Project	The Falls on Refugee Road	Addendum Number	3
Project Number	23446	Date	07/10/2025
To	All Bidders

This addendum contains changes to the requirements of the bidding Documents, Project Manual and Construction Drawings which have been issued to date. Such changes are to be incorporated into the Construction Documents and shall apply to the work in the same meaning and force as if they had been included in the original documents. Wherever this Addendum modifies a portion of a paragraph of the Project Manual or a portion of any Drawing, the remainder of the paragraph or Drawing shall remain in force.

H107-D-24217.DWG
PRATER
Engineering Associates, Inc.
6130 Wilcox Road
Dublin, Ohio 43016
DESIGNED BY
B. MCFERRIN
DRAWN BY
B. MCFERRIN
CHECKED BY
J. LOCKARD, P.E.
JOB NUM.
24217
(614) 766 4896
FAX: (614) 766 2354

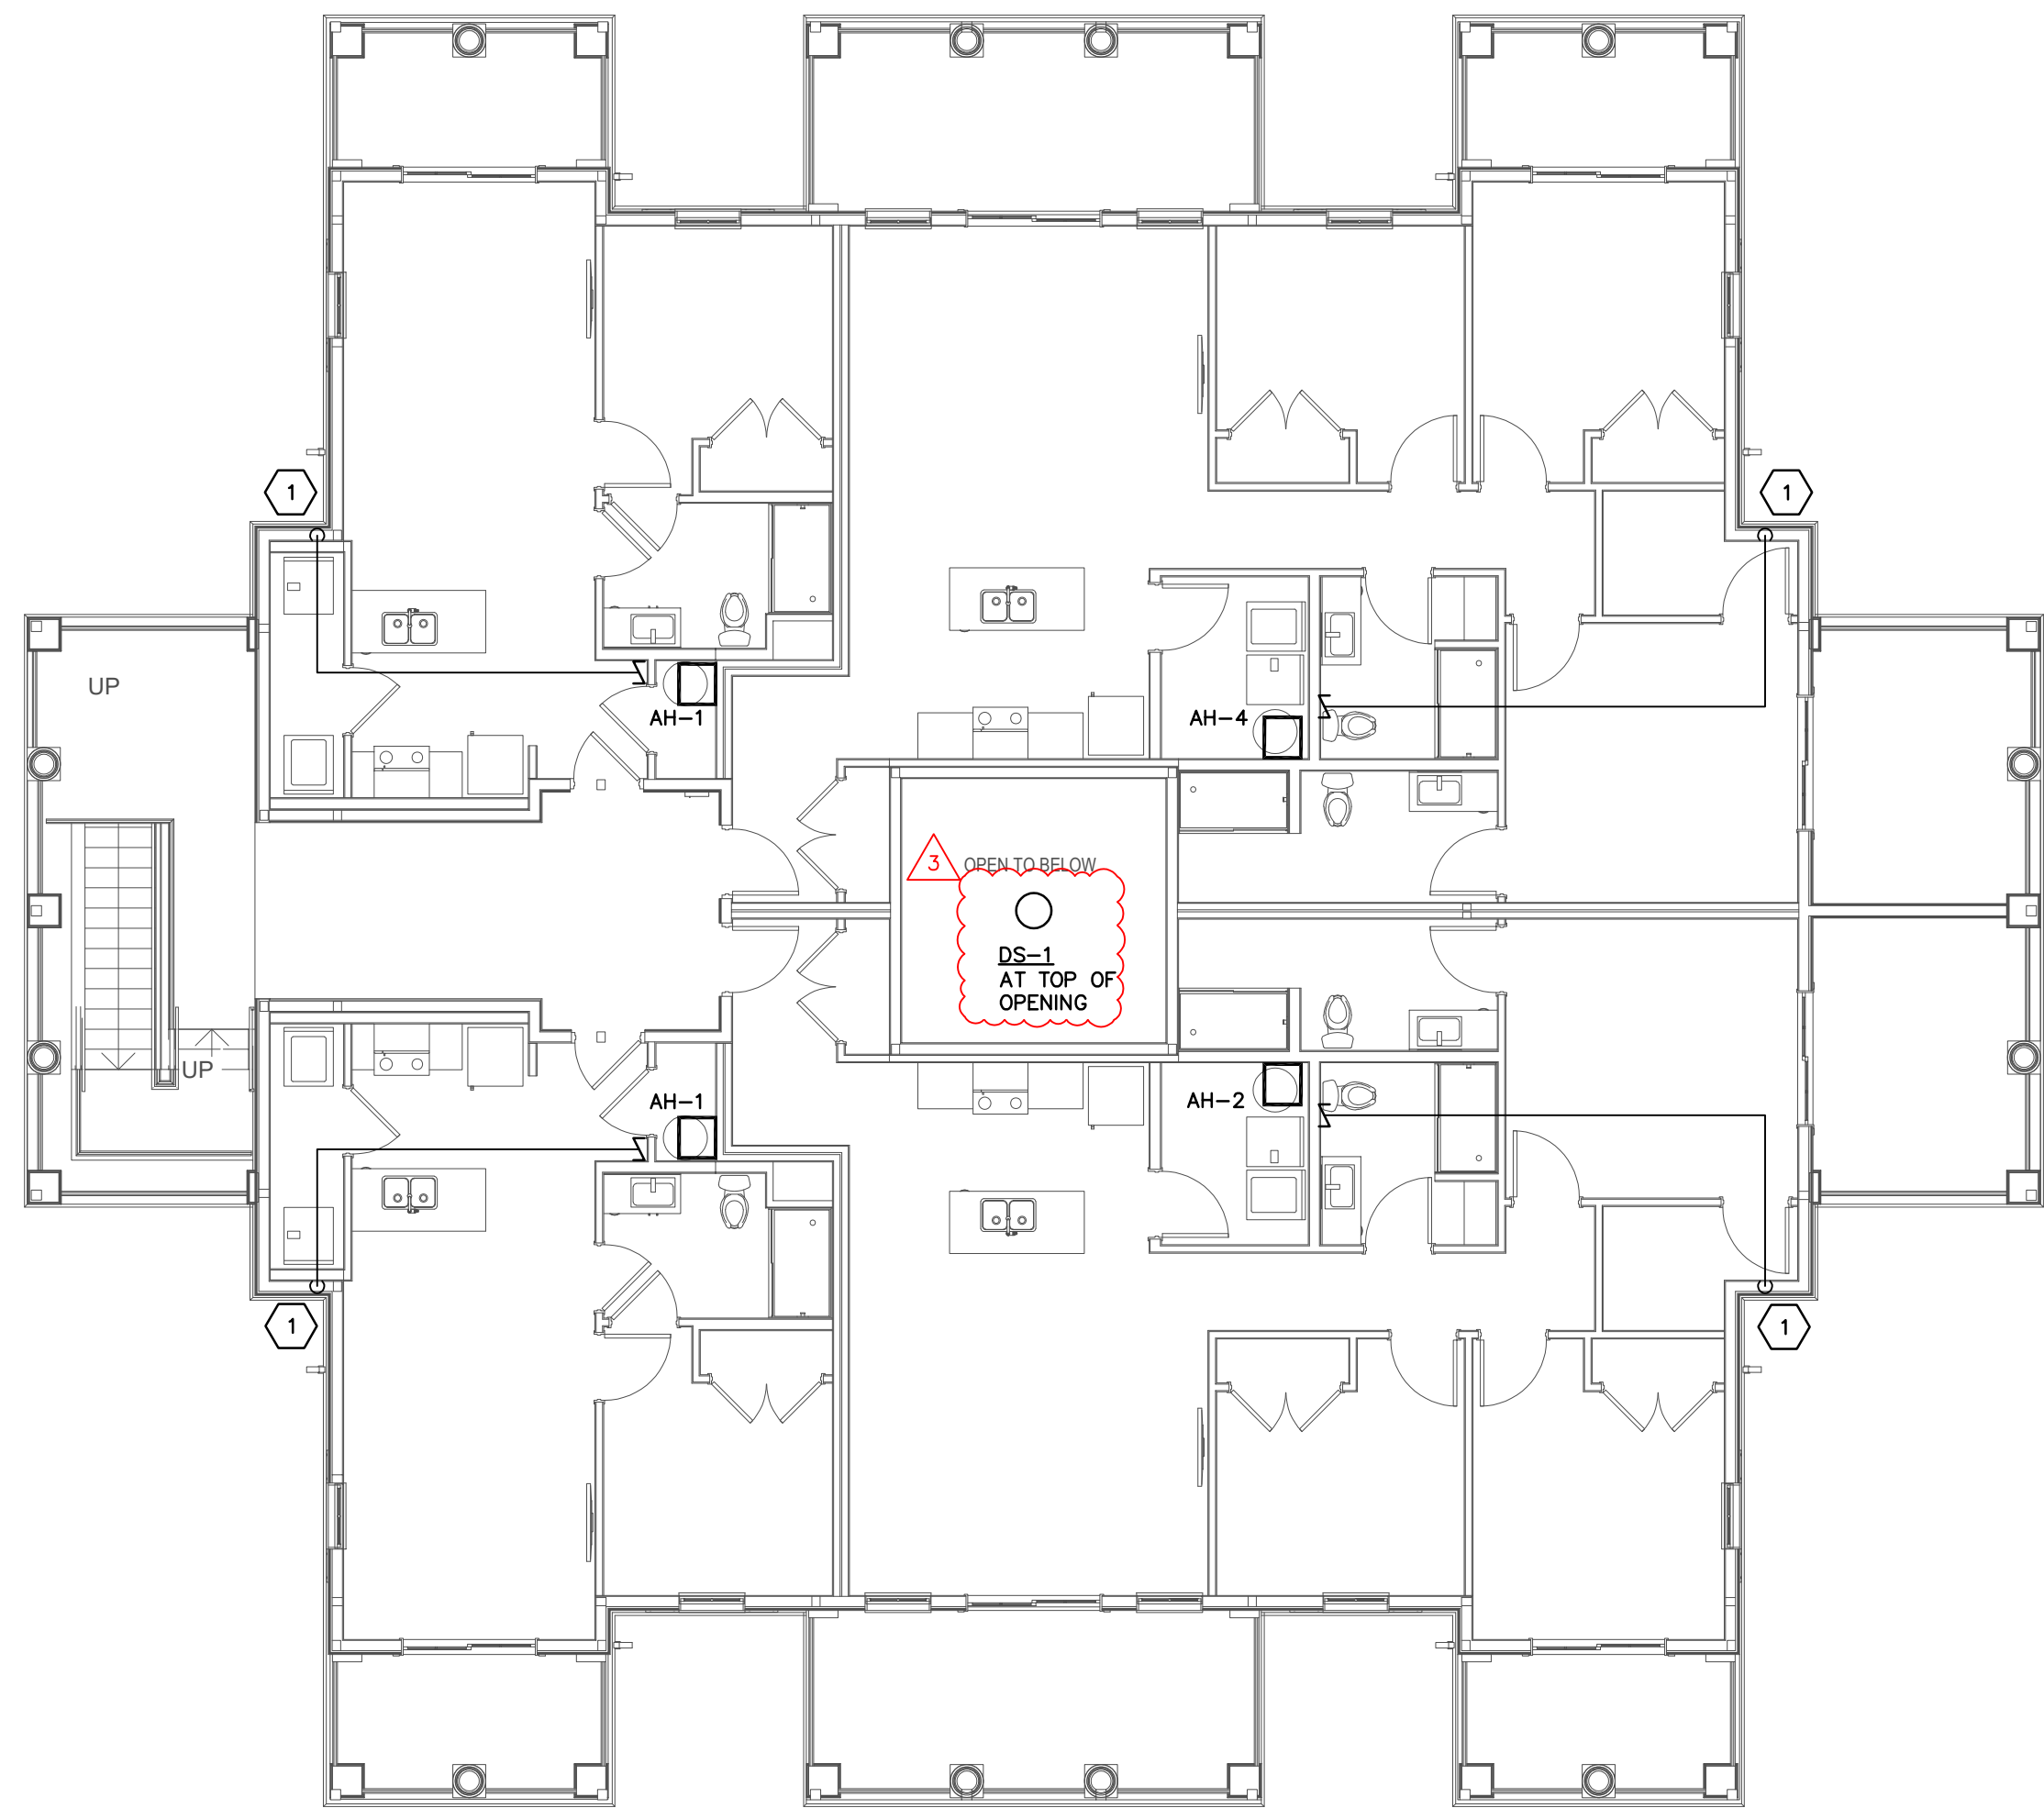
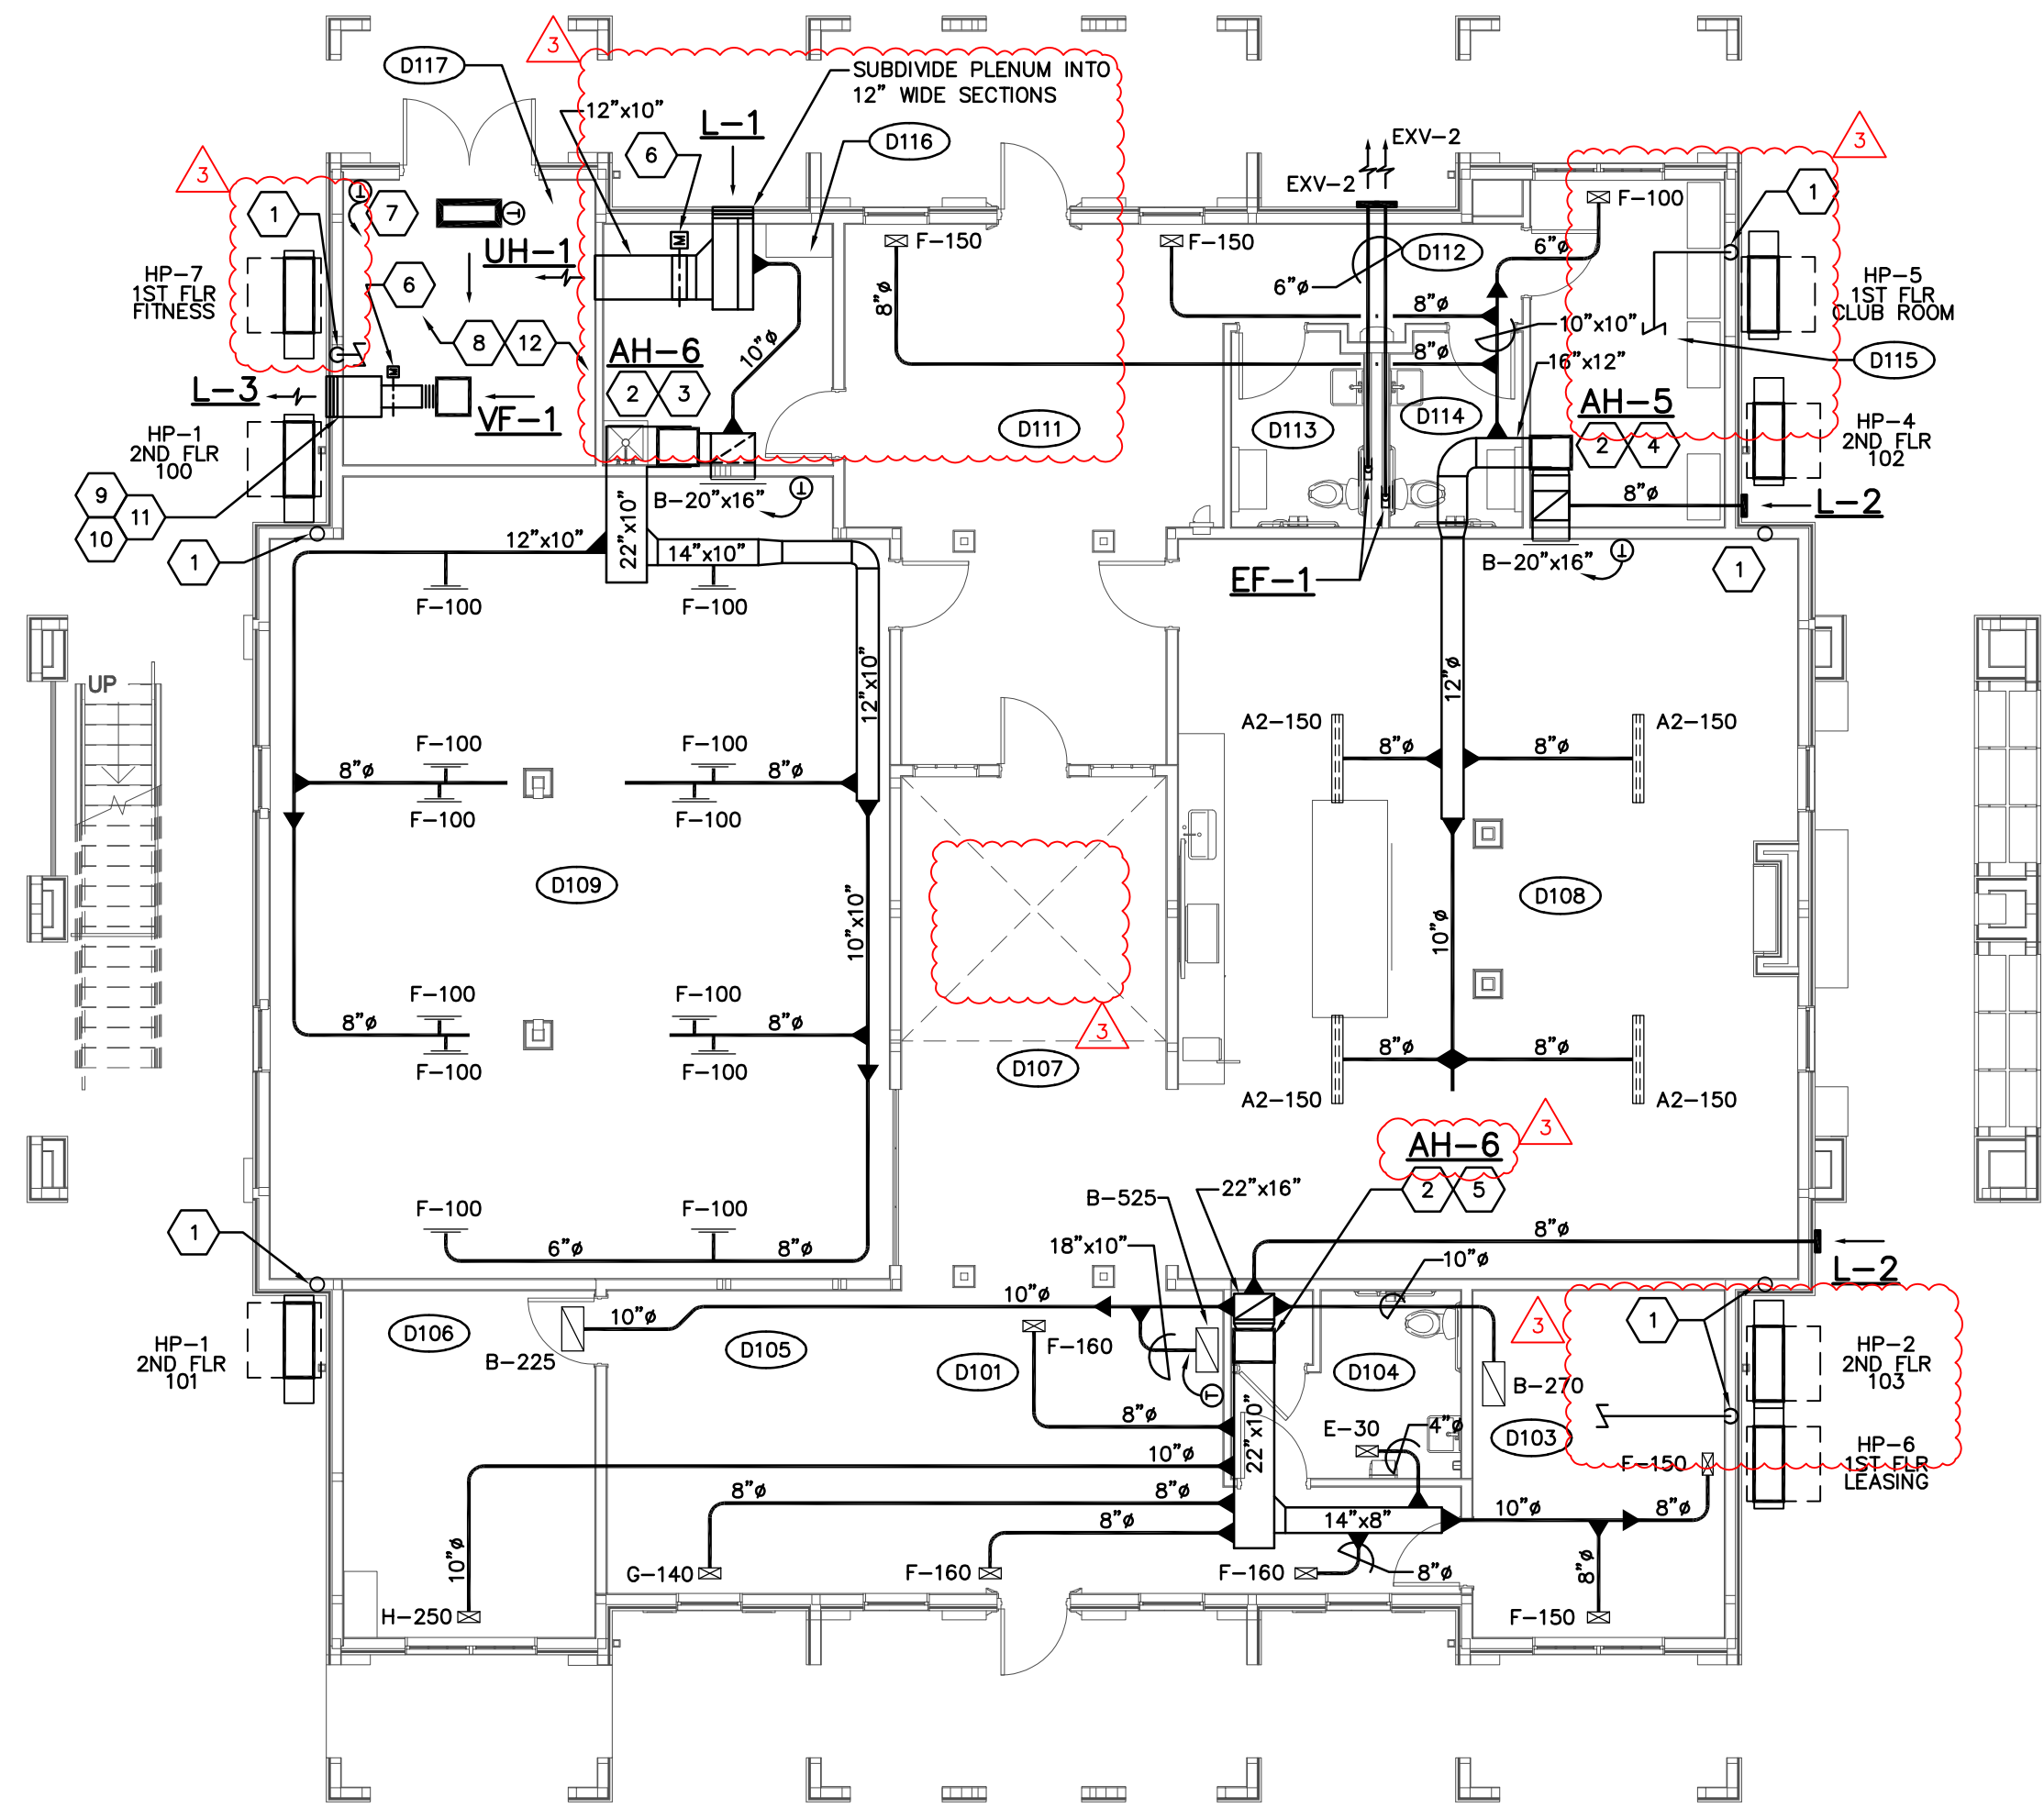
Sheet H107-D

1. Revised coded note #1 to call out the H301 sheet.
2. Revised refrigerant routing to go down inside wall cavity.
3. Moved DF-1 to level 02 to show at the highest elevation.
4. Changed louver tag from L-1 to L-3 on pool heater vent detail.
5. Revised duct routing and added note at D116.
6. Added refrigerant at the D103, D117, and D115.
7. Revised AH/HP designations for amenity spaces.
